# Rezoning Transportation Analysis

Petition Number: 2021-114

Date	Description
09-15-21	First Review (BKB)
10-18-21	Second Review (AO)
11-22-21	Third Review (PDM)

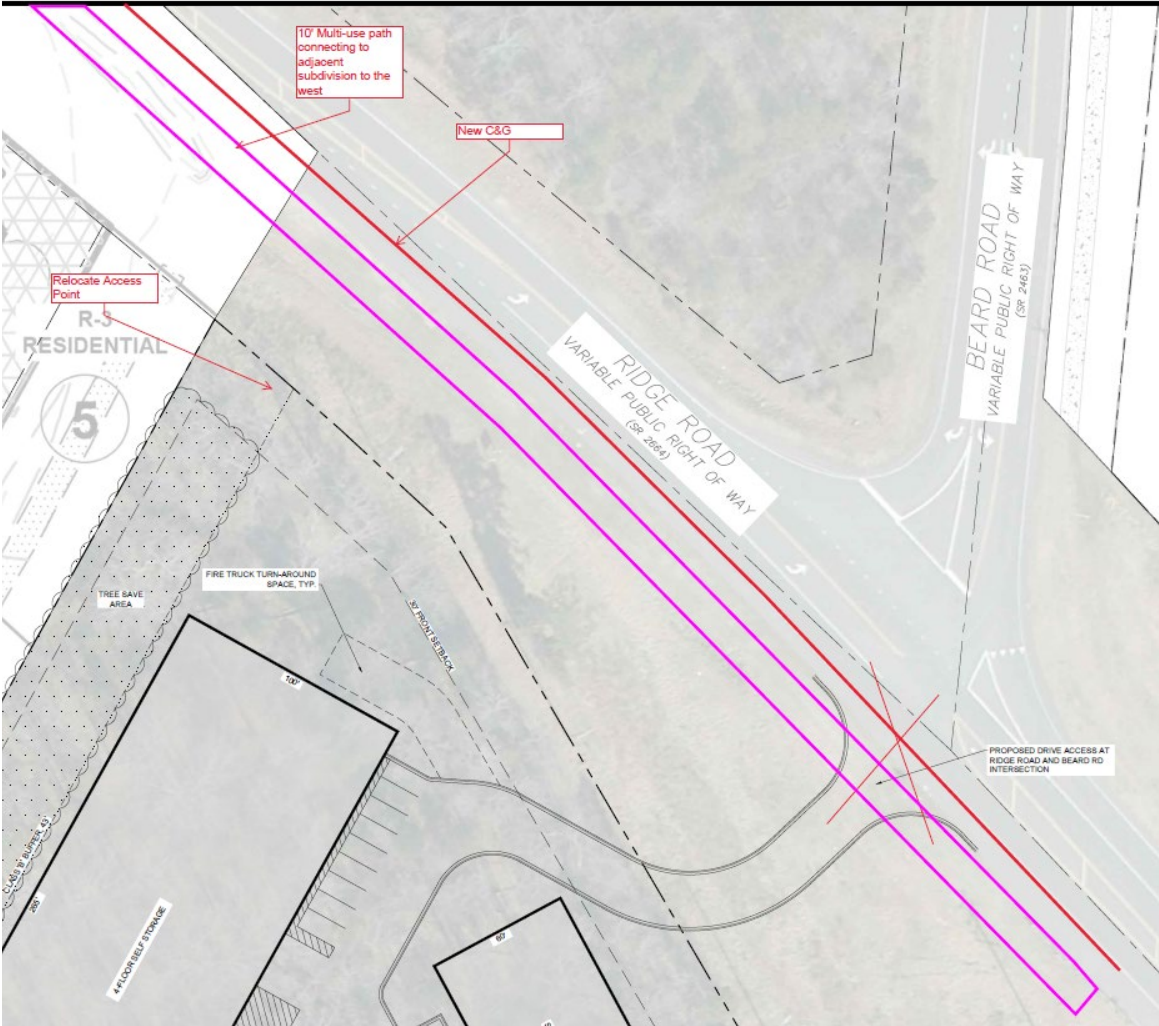
1. **Curbline:** The proposed zoning district has a setback measured from back of the existing or proposed future curbline.
  - a. **Ridge Road:** Provide curb and gutter along existing edge of travel lane along the entire property frontage. Use existing edge line for placement of gutter.

Label and dimension the curb and gutter from the centerline for Ridge Road on the site plan.

**Clarifying Comment from 9-15-21: Place curb and gutter off of edge of travel lane, not existing edge of pavement. Dimension the curb and gutter from the centerline of Ridge Road.**

**Clarifying Comment from 11-22-21: Place curb and gutter at edge of travel lane as depicted below.**

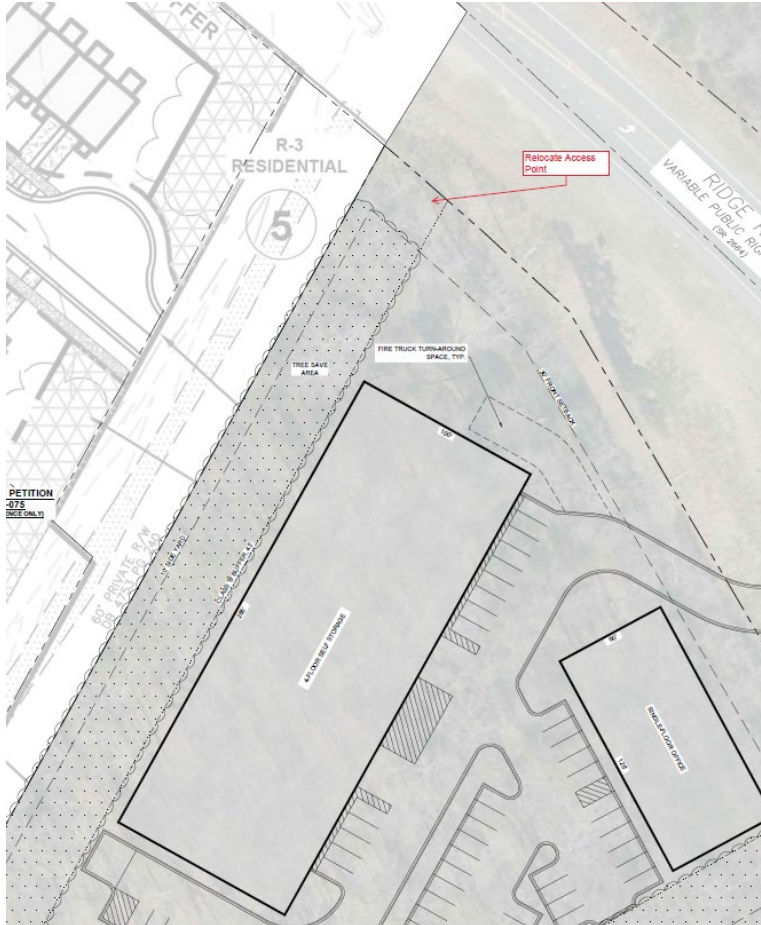
4. Site plan and revisions are needed to reflect the access point to the development on the western portion of the property per the below image. The existing Ridge Road and Beard Road intersection would require improvements that aren't commensurate with the development, so this relocated driveway will require less improvements of the developer within Ridge Road.
